**STAFF REVIEW FOR PLANNING BOARD APPROVAL  
CAMBER WOODS PRELIMINARY PLAT REVIEW**

Randall Edens of RSC Engineering, applicant, on behalf of owner, Evans Haines LLC, are seeking approval of Camber Woods preliminary plat subject to review by the Planning Board. This is a minor subdivision with a new street dedication.

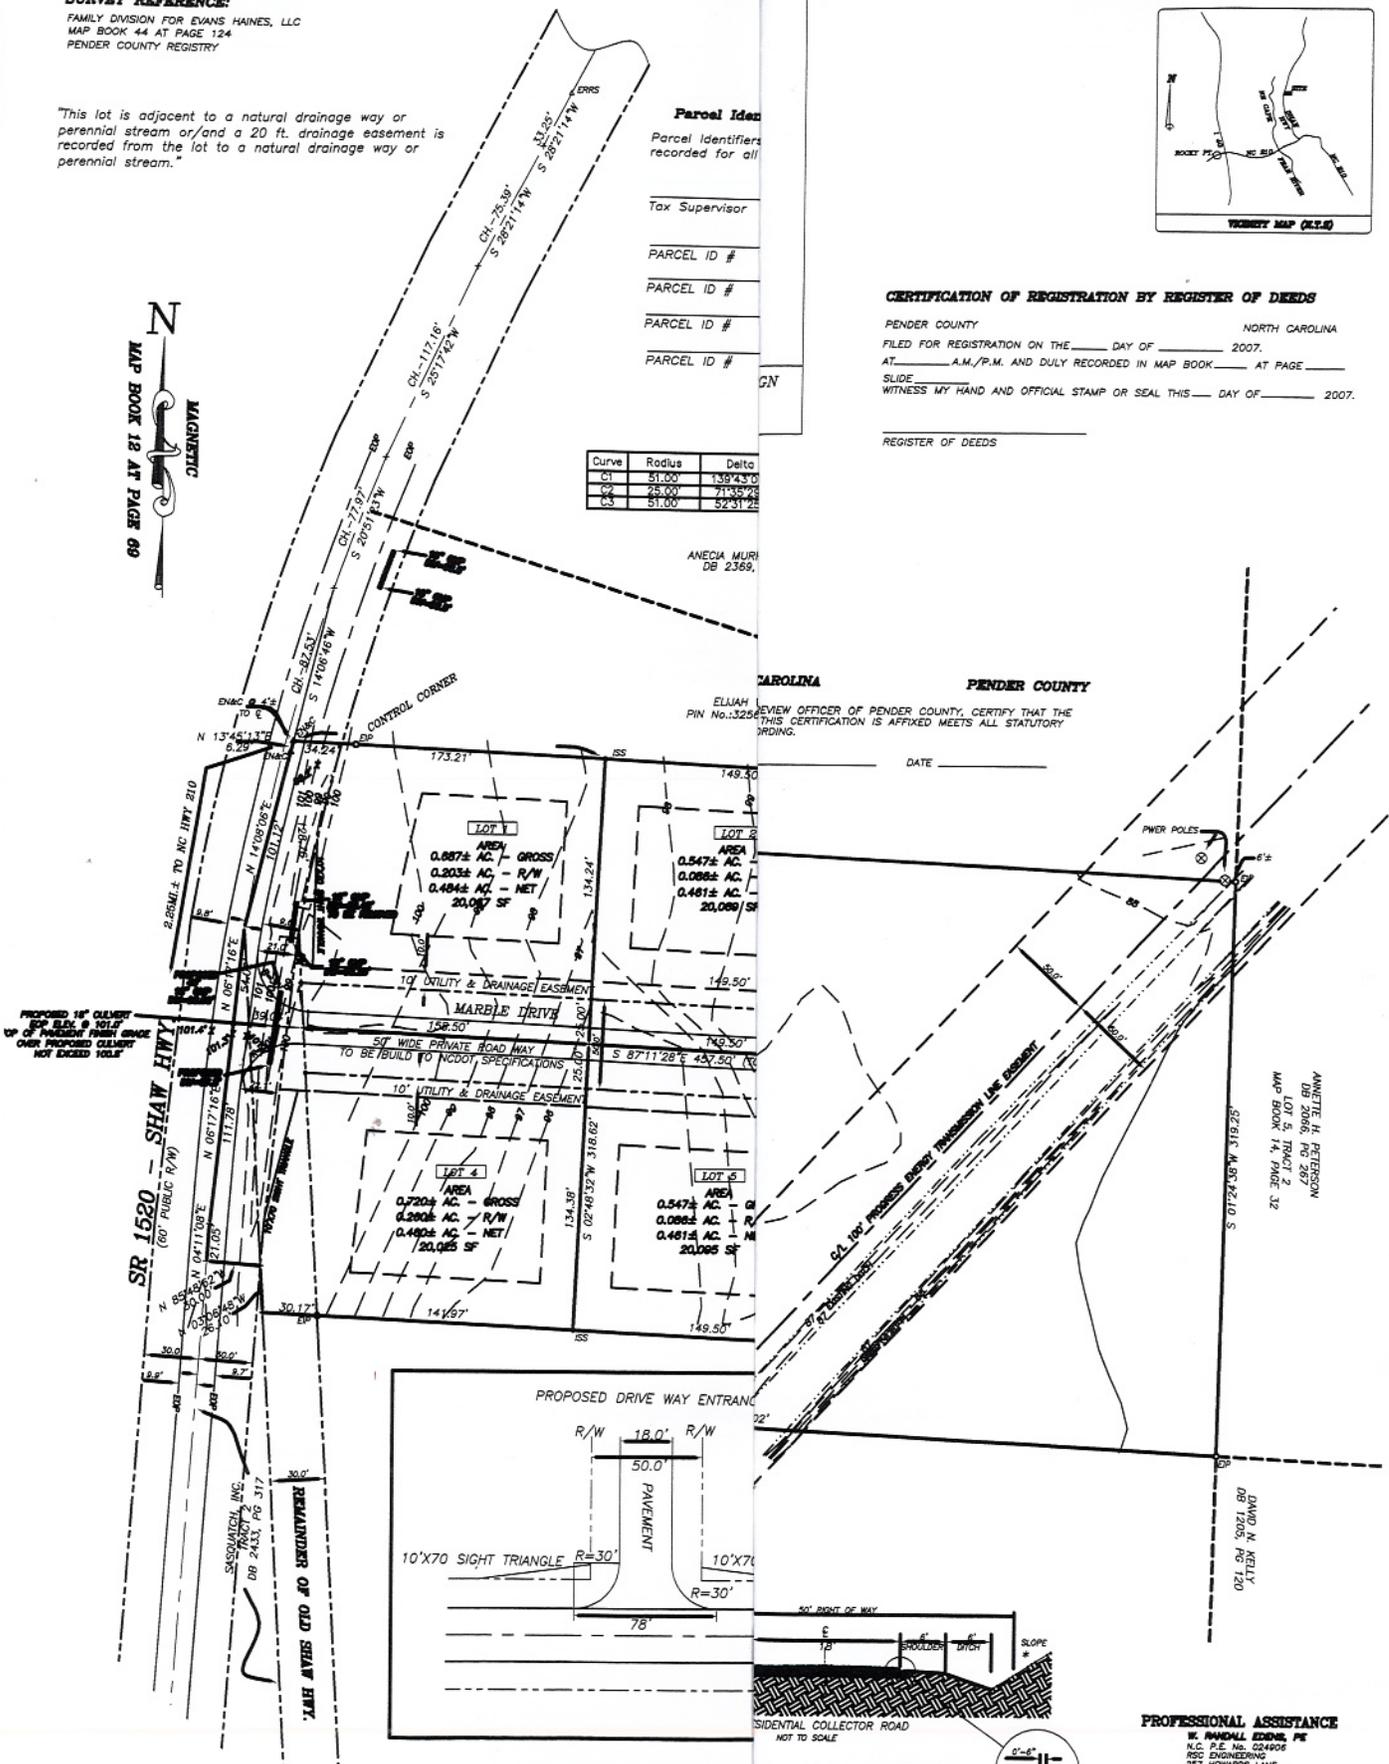
The applicant is proposing a total of 8 residential lots on the site with the total acreage of 10.62., with 1.557 acres of open space. This does not meet the county's open space requirement of 15%, .0366 acres or approximately 1,600 square feet more is needed to meet the open space requirement. The minimum lot size is proposed at 20,000 square feet. All land use and setback requirements under the Pender County Zoning Ordinance for the R-20 district will apply to lots 1-8.

The property does not contain any Special Flood Hazard Areas or Areas of Environmental Concern. However, based on a preliminary analysis, the property does contain wetlands between lots 6 and 8. These wetlands will not be disturbed and will be dedicated as open space.

Planning Staff is submitting the preliminary plat layout for Planning Board approval, with the condition that the open space requirement is met. The submission as presented tonight is sufficient for Planning Board disposition. Planning Staff recommends approval, with the condition of the additional .0366 acres of open space. Final Preliminary Approval will not be effective until all requirements of preliminary submission as prescribed in the subdivision ordinance are complete, the submission shows compliance with all subdivision and zoning requirements and the Director has signed a copy of the Preliminary Plat. The approval is also subject to the following conditions:
